Kansas Department of Agriculture  
 Division of Water Resources  
**CHANGE: P/D WORKSHEET**

RE: Field Office Application for Change  
Water Right, File No. 28330

RE: Application for Change in Point of Diversion  
Water Right, File No. 28330

## Evaluation of proposed move for Water Right No. 28330

## GMD3 Change Review

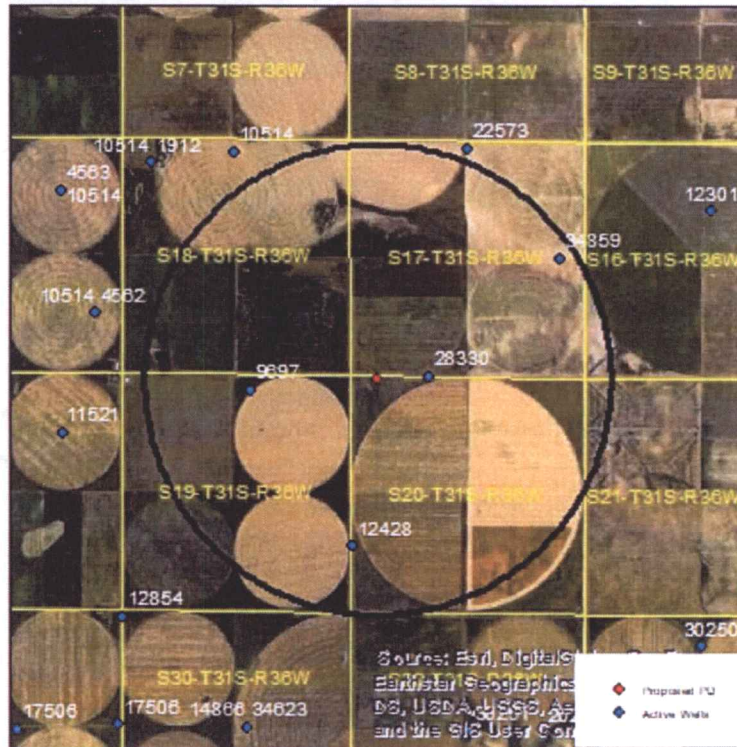
ft. North	ft. West	
Authorized PD	5275	3507	Sect 20-31-36
Proposed PD	5253	4803	
Difference	22	-1296 w	
$a^2 + b^2 = c^2$	484	1679616	1296.187 foot move west

Is a waiver needed: Move is less than half mile. Minimum spacing to neighboring wells appears met. Analysis showed results within guidelines and no critical wells.  
Recommendation: After review of all available information, appears current area rules appear met. Staff therefore recommends approval.

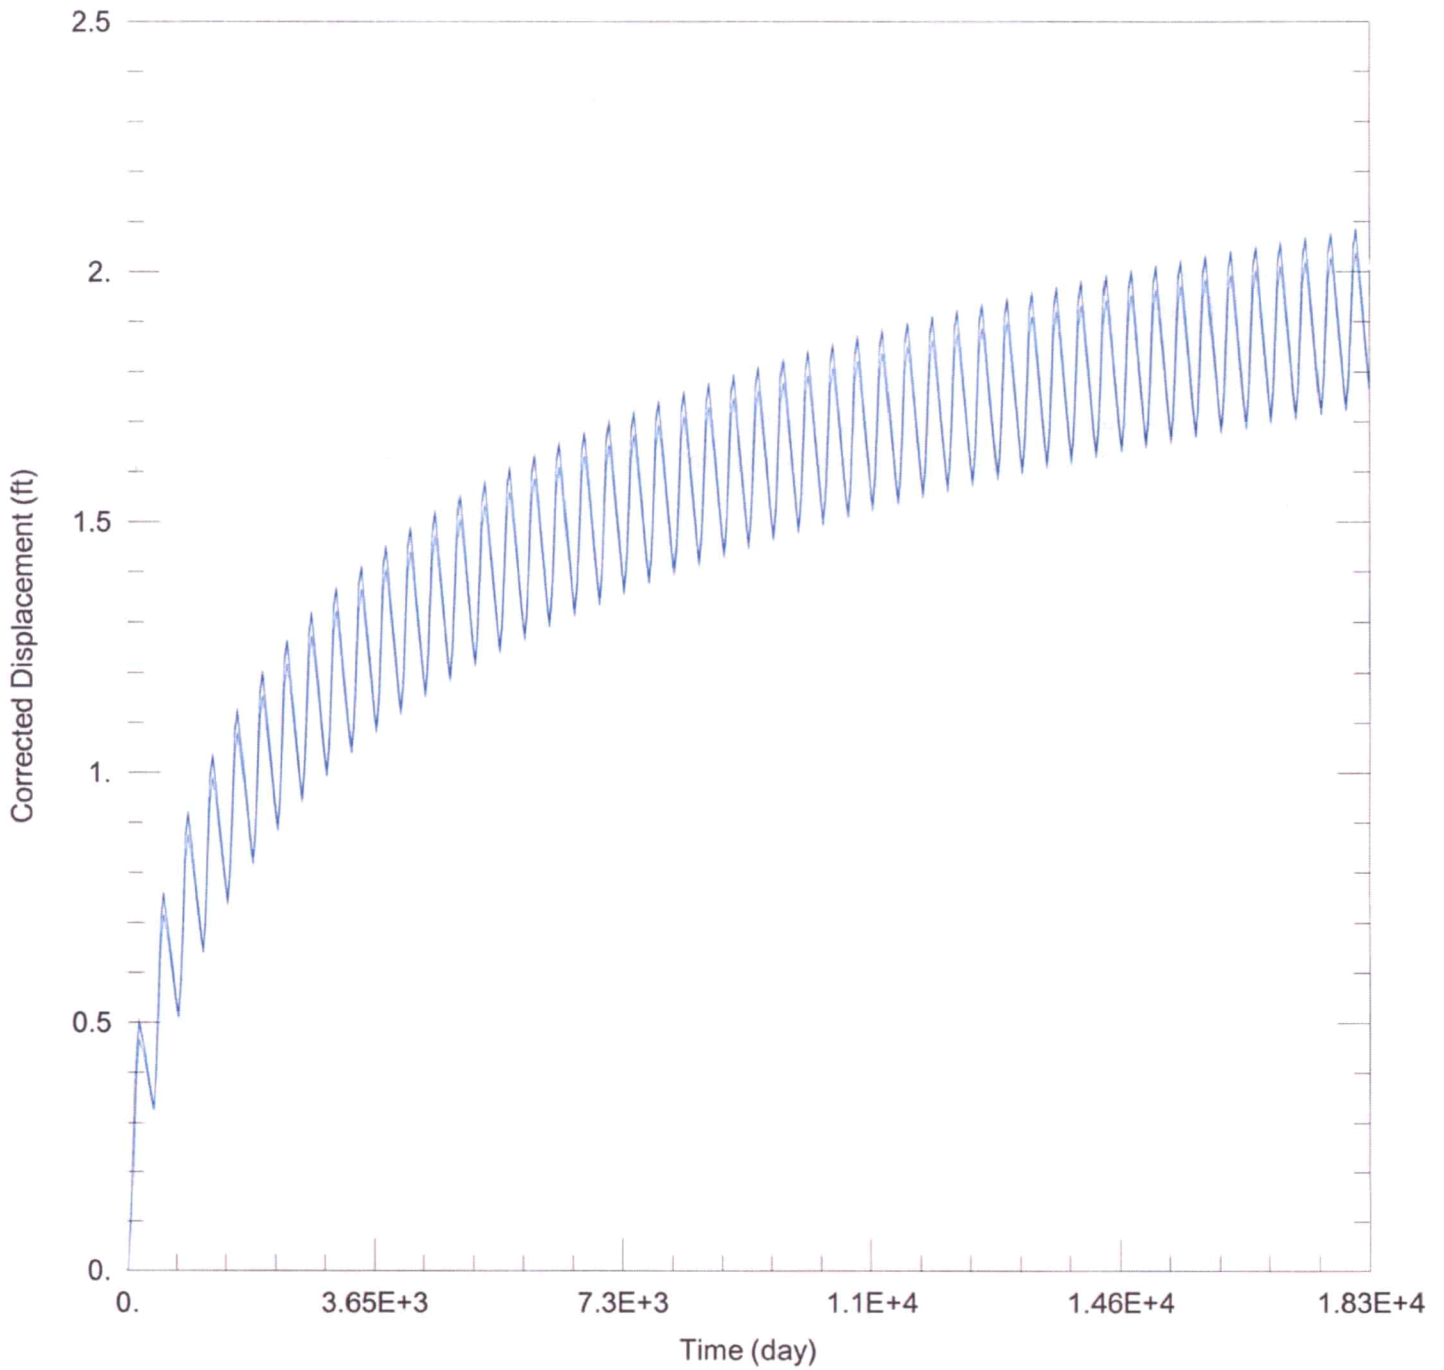
The saturated thickness at the proposed well location is estimated to be 211 ft, based upon driller's log and an observation well in section 13-31-37. For saturated thickness greater than 200 ft, the drawdown allowance is 4.0 ft.

$S = 0.2539$ ,  $T = 9414.5 \text{ ft}^2/\text{day}$ ,  $t_{p\text{current}} = 102 \text{ days}$  (based on average use and observed rate),  
 $Q_{\text{current}} = 925 \text{ gpm}$  (based on 2020 field inspection),  $t_{p\text{proposed}} = 127 \text{ days}$ ,  $Q_{\text{proposed}} = 1400 \text{ gpm}$

Net drawdown does not exceed the drawdown allowance of 4.0 ft for any well within 1 mile of the proposed location. Therefore, critical well analysis is not necessary.

The proposed move is likely to create minimal effects on neighboring wells and appears unlikely to cause impairment. Any concerned neighbors should contact GMD3 at (620) 275-7147 or the Division of Water Resources at (620) 276-2901.
